FACILITY: Diablo Canyon Nuclear Power Station, Units 1 and 2 (Diablo Canyon)

SUMMARY OF MEETING HELD ON AUGUST 11, 1976 TO DISCUSS SEISMIC REEVALUATION OF DIABLO CANYON

DIABLO CANYON NUCLEAR POWER PLANT
DOCKET NOS. 50-275, 50-323
STRUCTURAL ENGINEERING BRANCH
DRAFT REQUEST FOR ADDITIONAL INFORMATION

INTERIOR CONTAINMENT STRUCTURE TORSIONAL MOTION

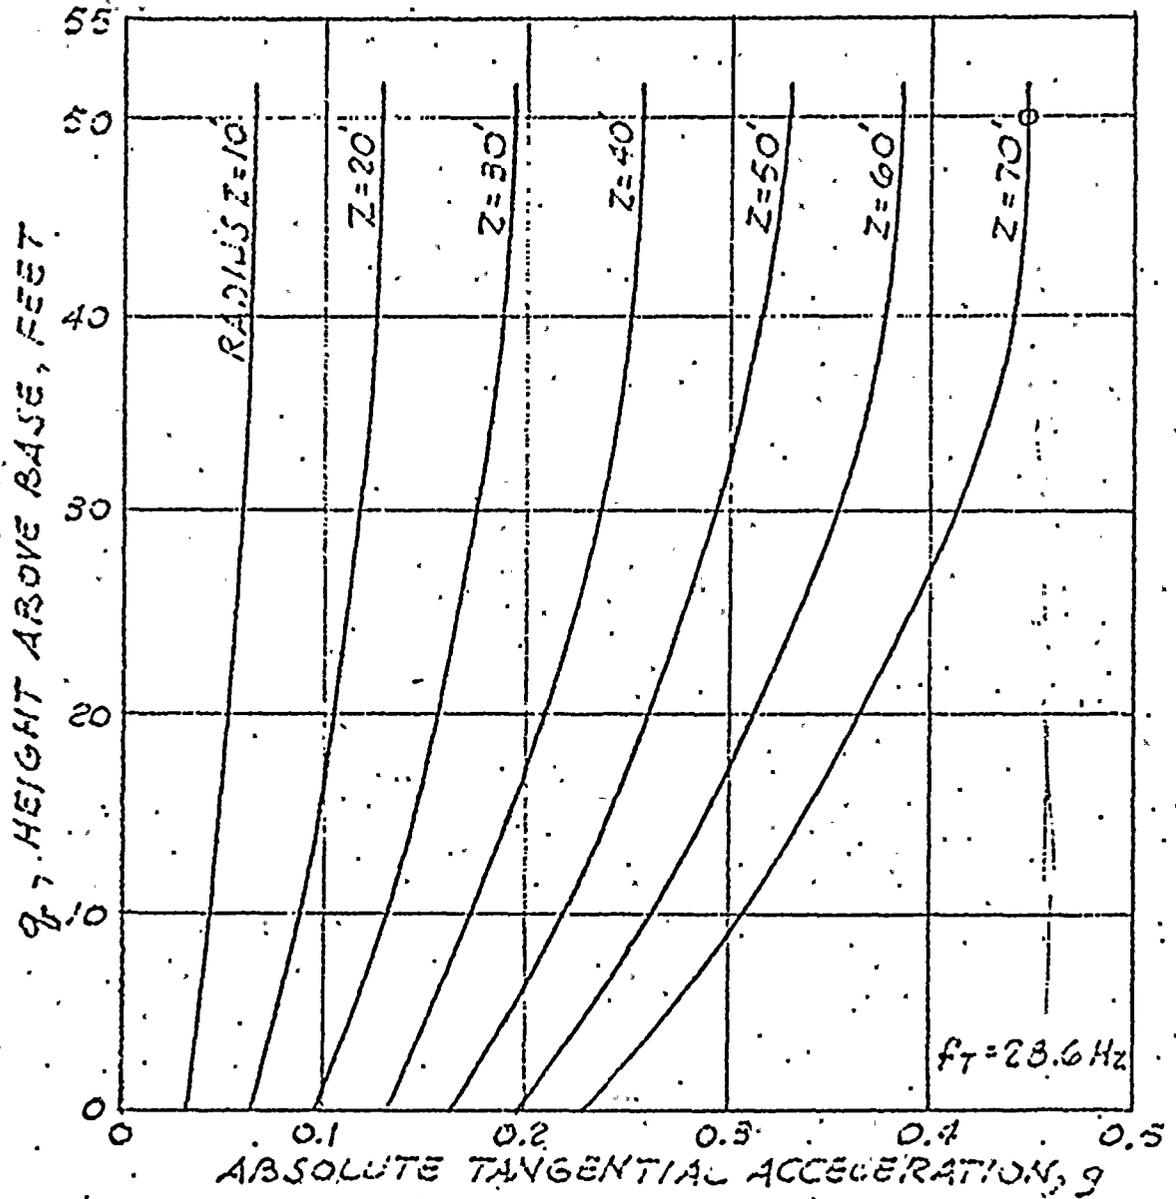
6. Question) Provide justification for the statement that "torsion represents a relatively small contribution to the total seismic load".

Reply) Figures T1, T2, and T3, attached, show absolute tangential acceleration for various heights and radial distances in the Exterior Containment Structure, the Interior Containment Structure, and the Auxiliary Structure, respectively. These plots are based on the submitted Appendix 3.7A and the supplementary data provided under Question No. 15. The circles in these plots represent cases of q and z (height, q, above base and radius, z) that will be considered herein as extreme situations. Most qz pairs will be much less critical.

FIG. N — COMPARISON OF SPECTRAL CURVES, $\tau = 0.08$, Dp 7%

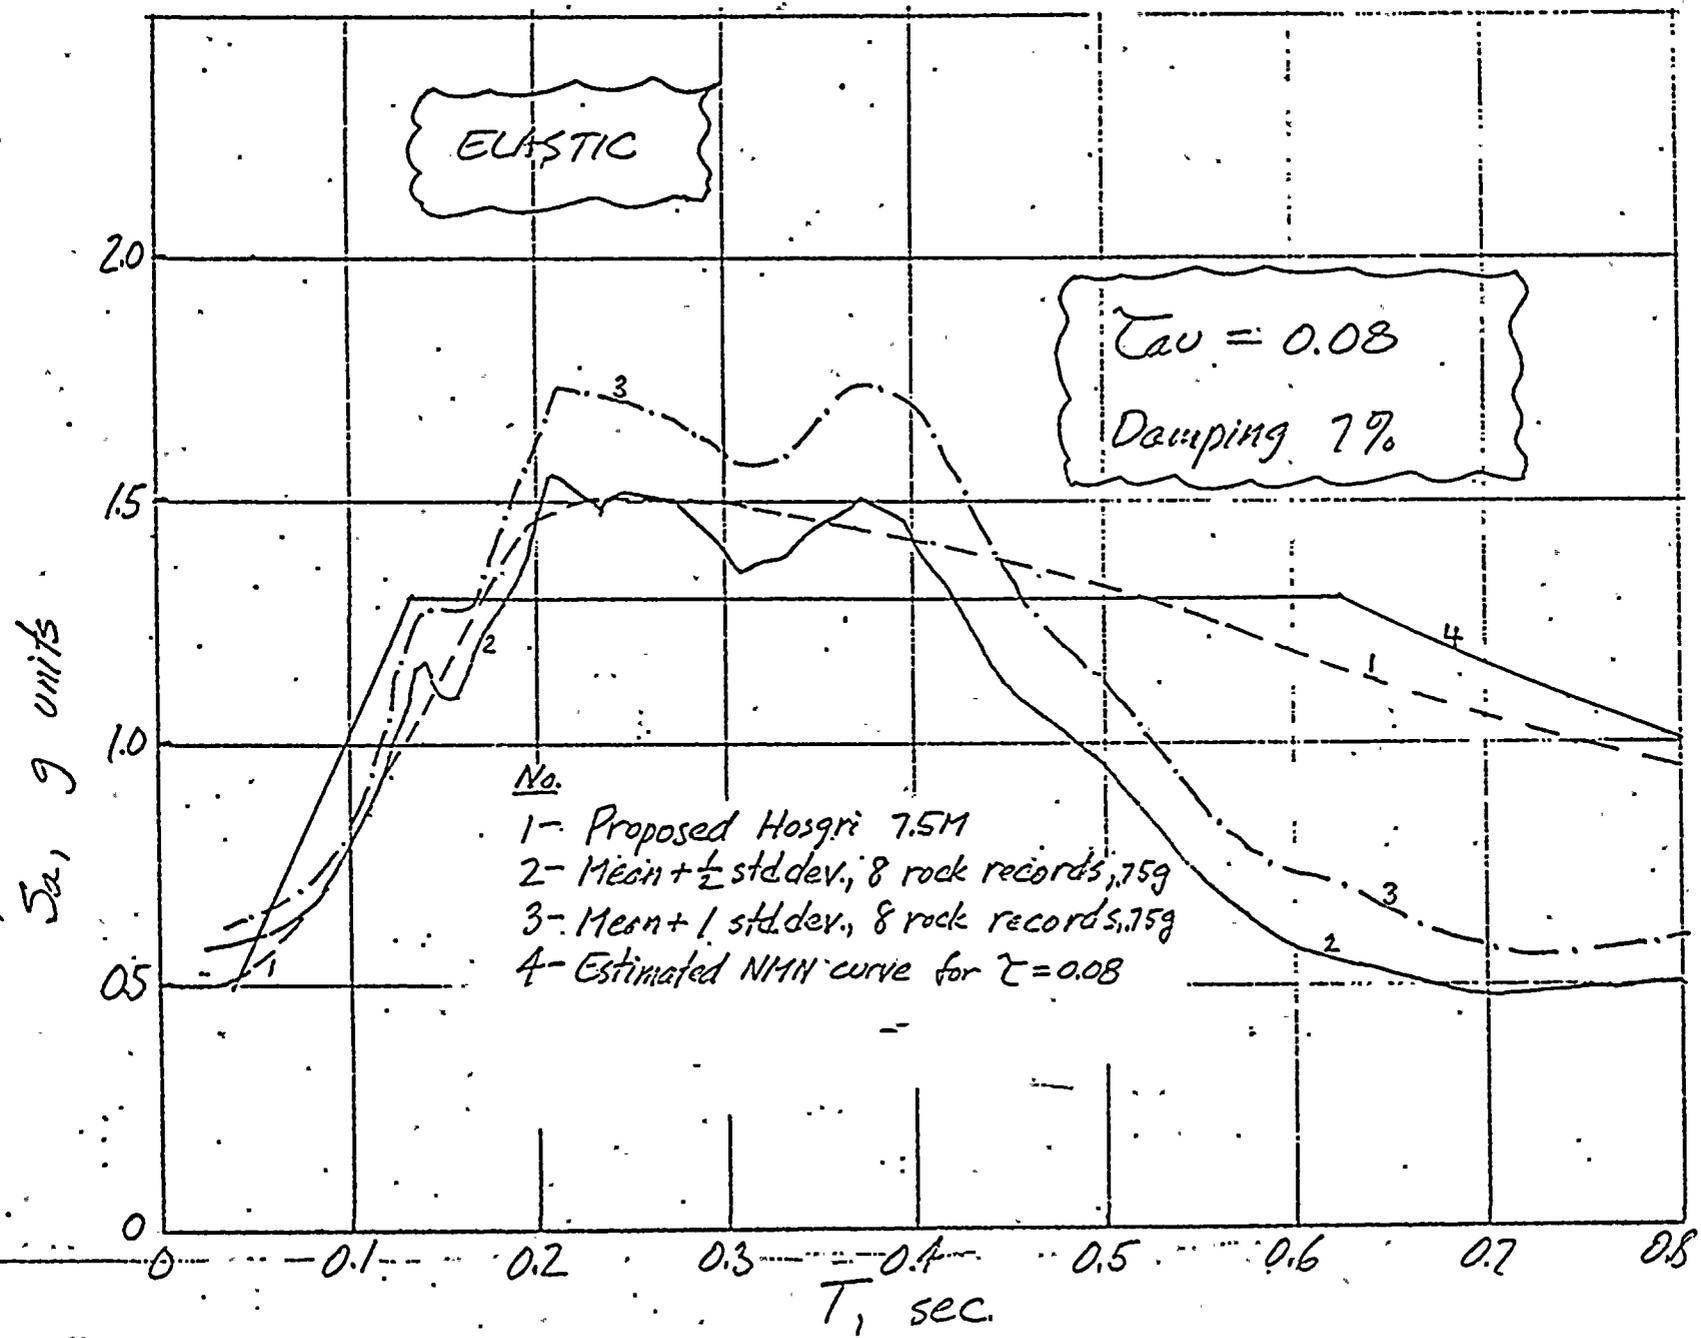
14. Question) Provide justification for the differences in response spectra obtained as compared to the response spectra recommended by Dr. Newmark in his report to NRC. The differences appear to be large around 2 cps and between 10 to 30 cps (especially in Fig. 13).

Reply) The differences between Dr. Newmark's curves and the curves submitted are not great considering the fact that there were completely different sets of data and different approaches used by Dr. Newmark and Dr. Blume who used 8 close-in rocky-site records, with adjustment for magnitude scaling which are considered to be the best available models for the conditions at Diablo Canyon. Dr. Newmark's data, although including more records, generally includes alluvial sites and greater epicentral distances.

There are scaling differences between Dr. Newmark's Table 1 and his curves. For that reason we have used his Table 1 numerical data for comparison. In Figure N we have plotted an interpolated "NMN" curve for $\tau = 0.08$ taken at 1.3g which is between his values for τ of 0.04 and 0.12. There seems to be no difference at 2 cps (0.5 sec period) and rather minor differences at longer periods. We don't think Dr. Newmark would insist upon his "corner" points which develop from straight line plotting convenience.

We exceed Dr. Newmark between 0.175 and 0.50 sec period, because that is the way our data fell.

At the high frequency end there are some differences, some of which may be due to our interpretation of his plots. In any event, we have generally followed our data and feel the results are adequate for the problem at hand.
